DiskOnChip 2000

Subject:	Product improvement		
Products:	DiskOnChip 2000 DIP (High-profile)	Part Number:	MD2203-DXX-V-T
Update #:	PU0401	Date:	February 18, 2001

MECHANICAL DIMENSIONS:

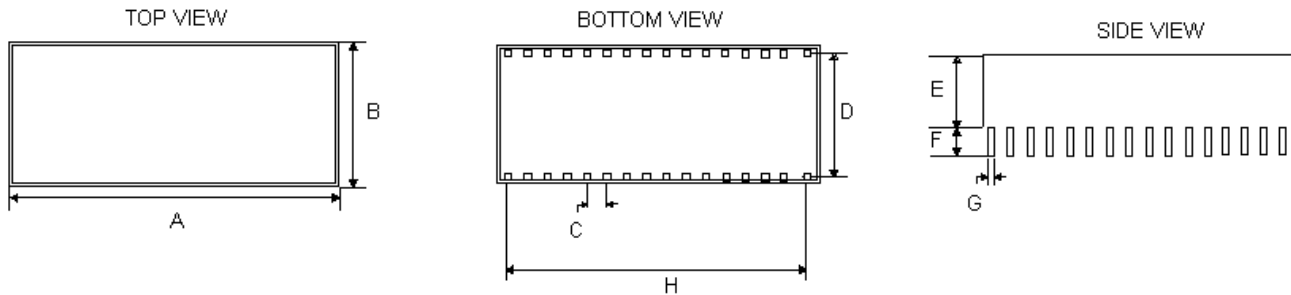
This product upgrade is part of M-Systems' constant effort to improve DiskOnChip products and guarantee higher reliability, endurance and safety standards. Due to improvements in the manufacturing process of the products, the dimensions of the high-profile DiskOnChip 2000 (MD2203-DXX-V-T) will be slightly modified. The attached table compares the dimensions of the new high-profile DiskOnChip DIP with the previous version it replaces.

MD-2203-Dxx (High-Profile)		
	New Dimensions (max.)	Previous Dimensions (max.)
A	45.6 mm	43.95 mm
B	18.8 mm	18.3 mm
C	2.54 mm	2.54 mm
D	15.24 mm	15.24 mm
E	13.5 mm	13.0 mm
F	4.0 mm	4.0 mm
G	0.51 mm	0.51 mm
H	38.2 mm	38.2 mm
